**MASTER DRAINAGE STUDY
UPDATE #2 (ADDENDUM NO. 2)**

Skye Canyon
City of Las Vegas, Nevada

Job No.: OLY1401.001
Date: October 2015

**Subject: Addendum #2 to the Master Drainage Study Update #2 for Skye Canyon
(CLV # DS4420)**

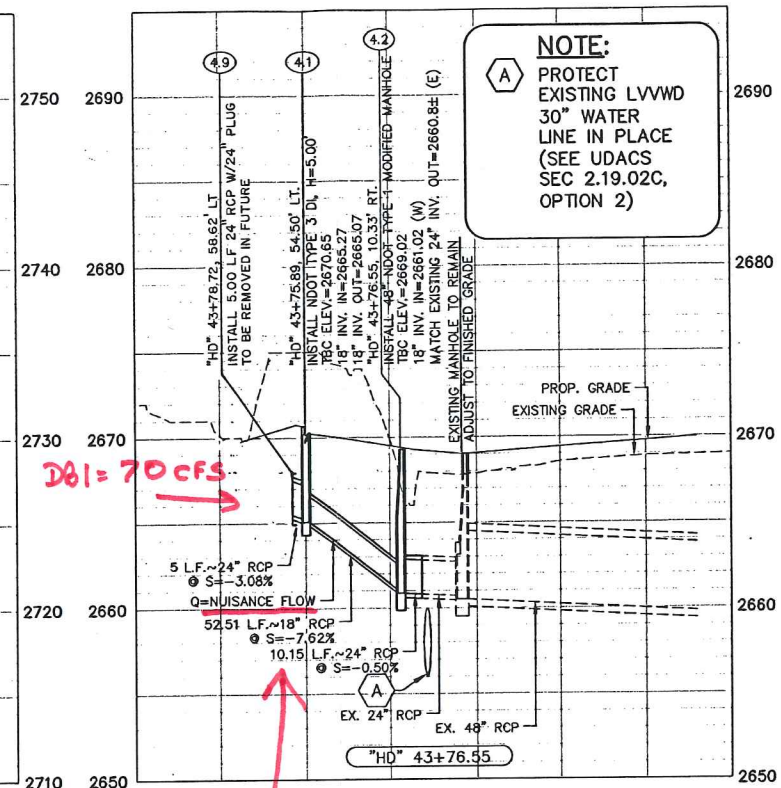
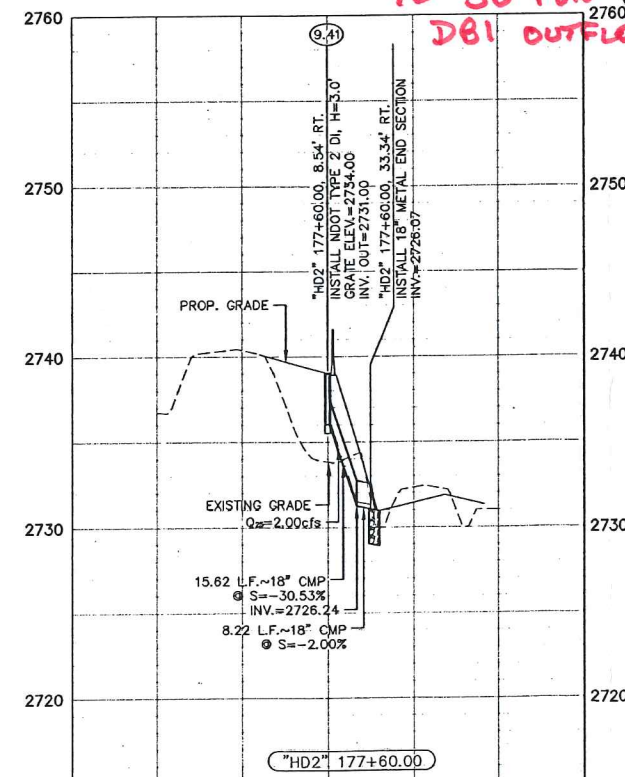
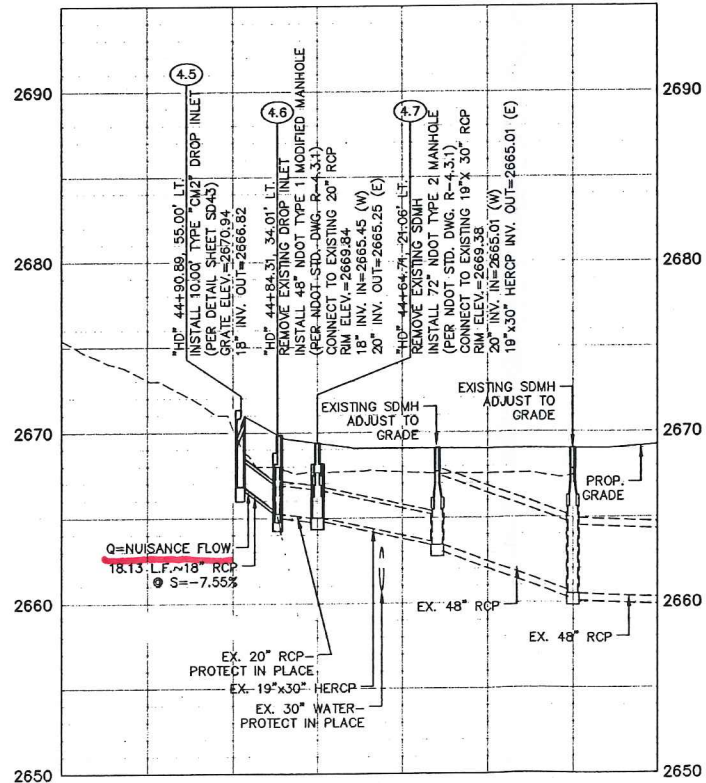
18" x 24" PIPES
REQUIRE UPSIZING
TO 30" FOR
DBI OUTFLOW
